HTH - Block B doors

Subject: HTH - Notice of Discrepancy N 054 - Block B window alterations

PROJECT / DRAWING TITLE
Hamsey Town Hall

DRAWING TITLE
RESIDENTIAL BLOCK B
North Elevation

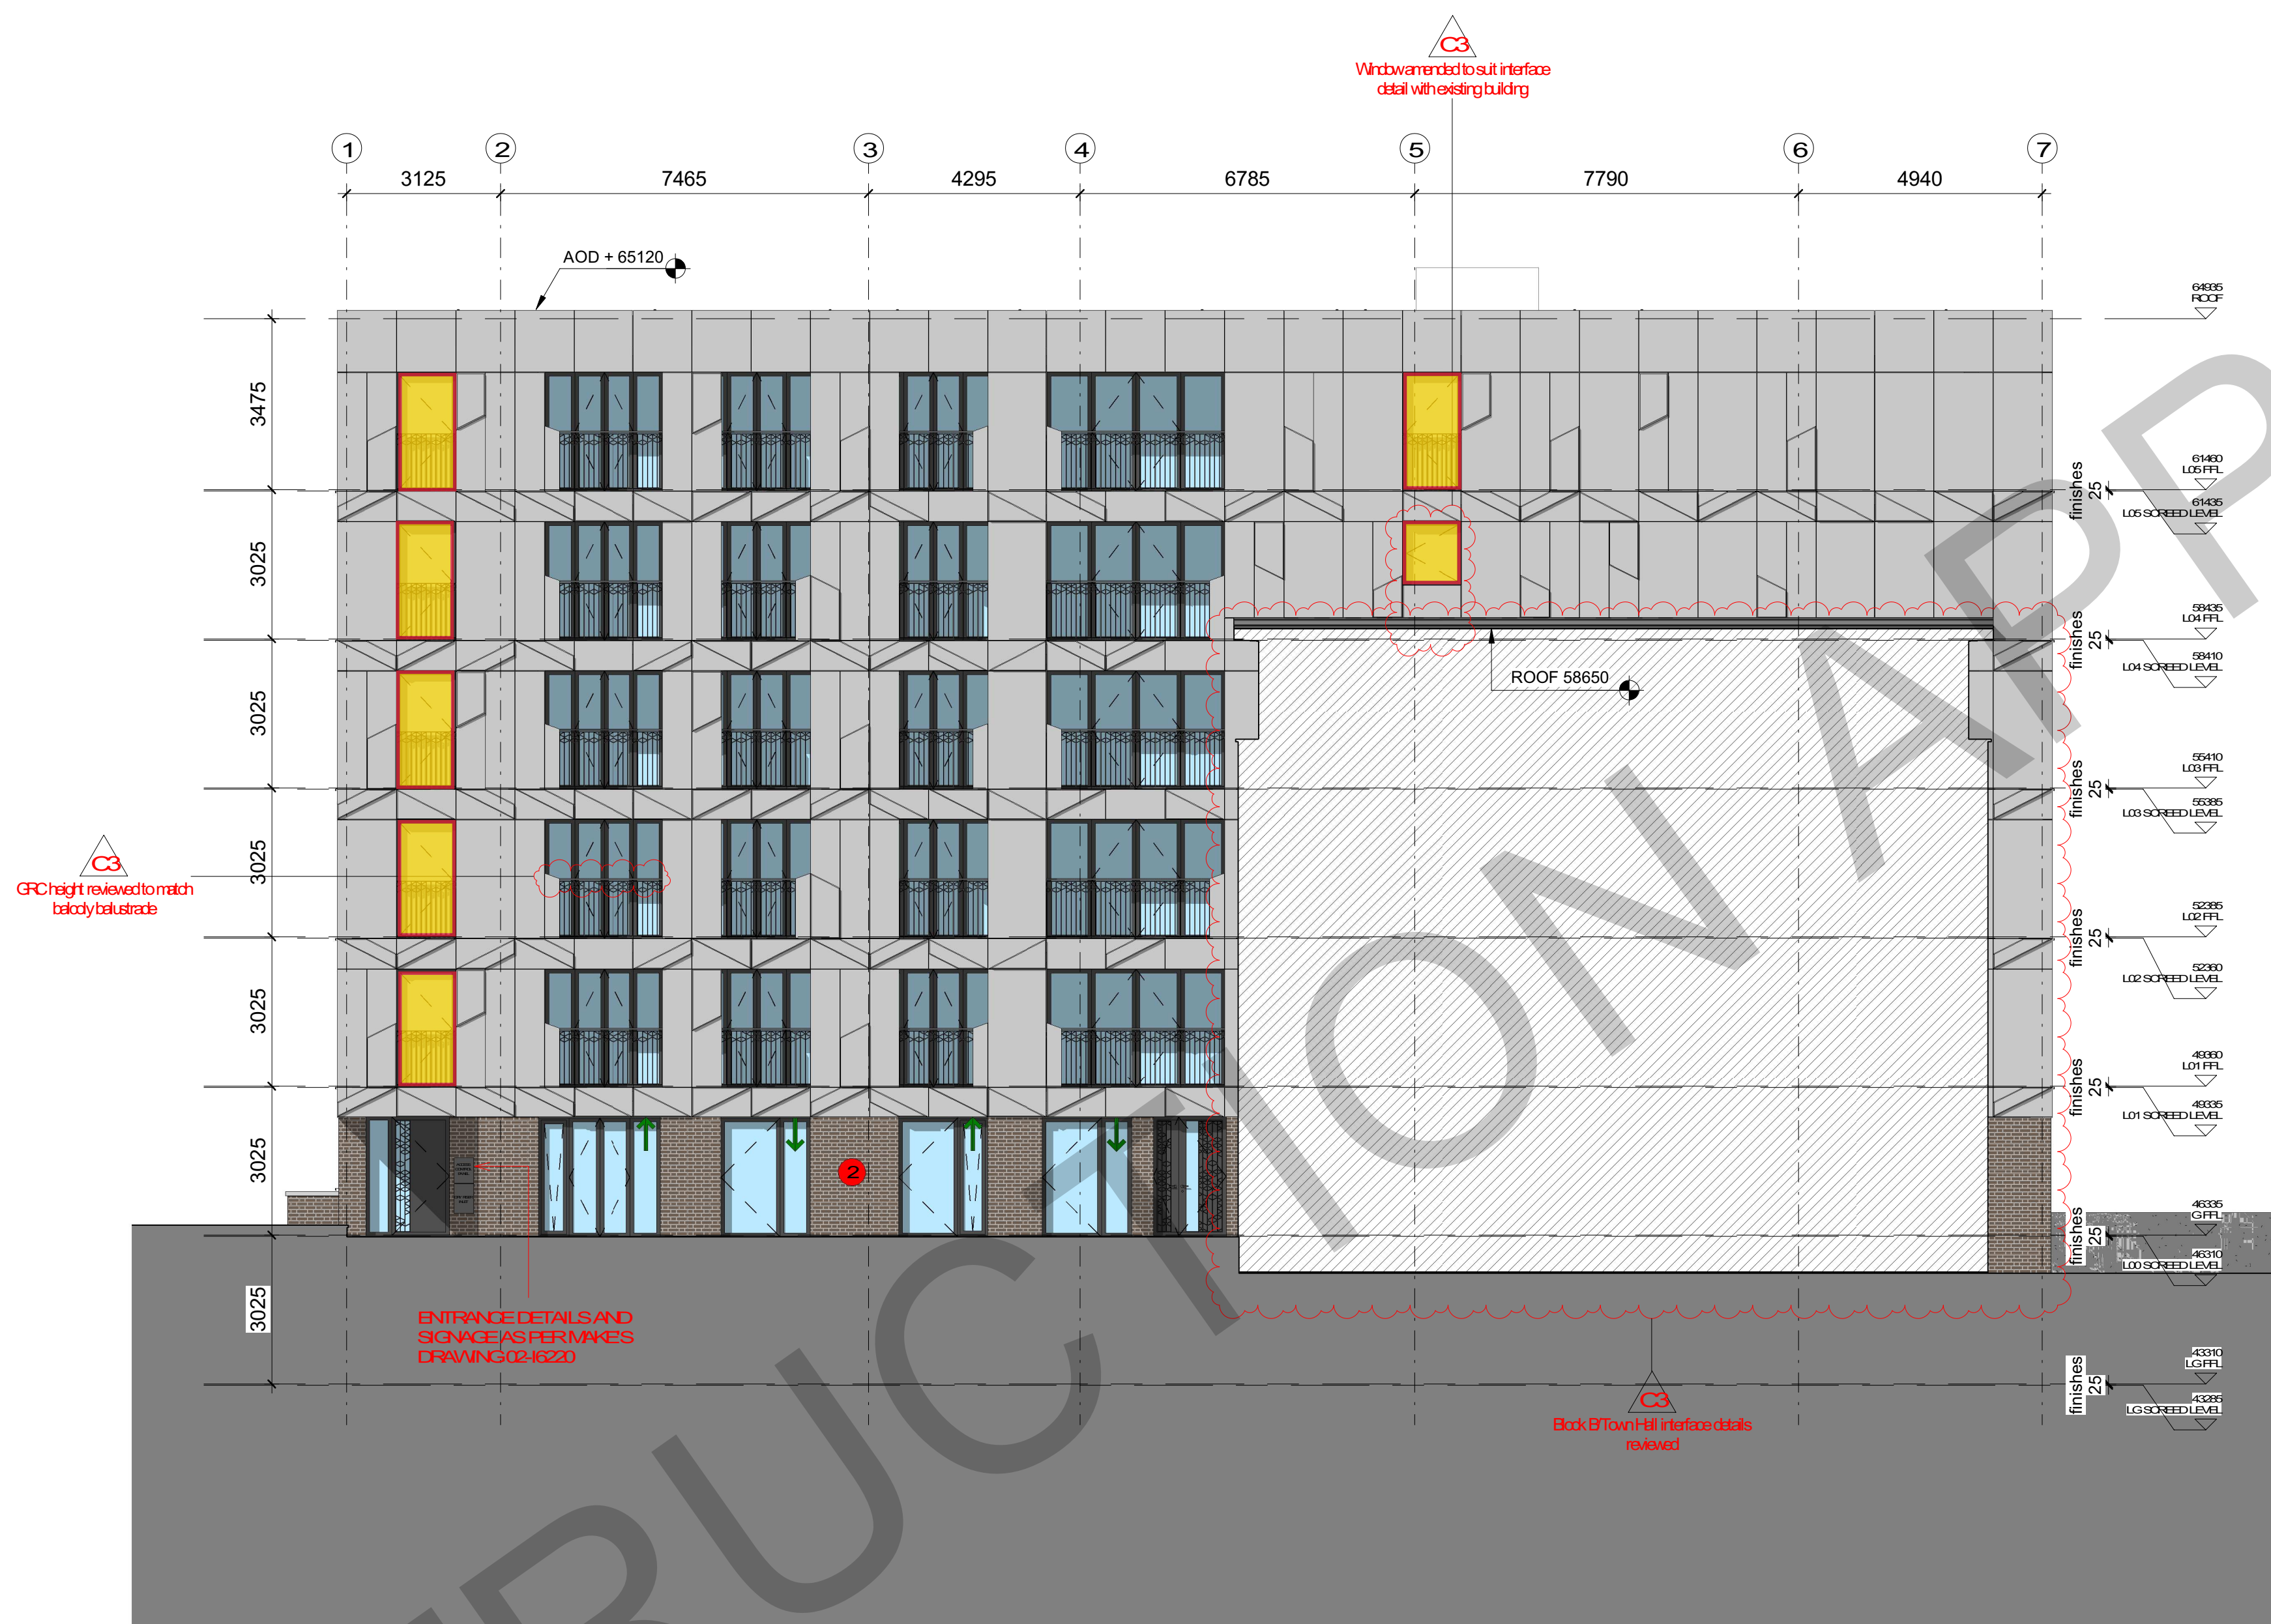
We are having problems with the window sizes of block B due to the weight of glass.

Can you please indicate if we made the doors within the attached mark up into half height windows with top section opening, what does this do to the overheating calculations. The opening transom would be in line with the current balcony height.

Even if you just change the worst rooms on the model to make it quicker for you that would be good enough for a high level overview.

Windows / door to have a max frame width 890mm. The window / door will be produced with a factory fitted packer to achieve the ER required S/O widths.
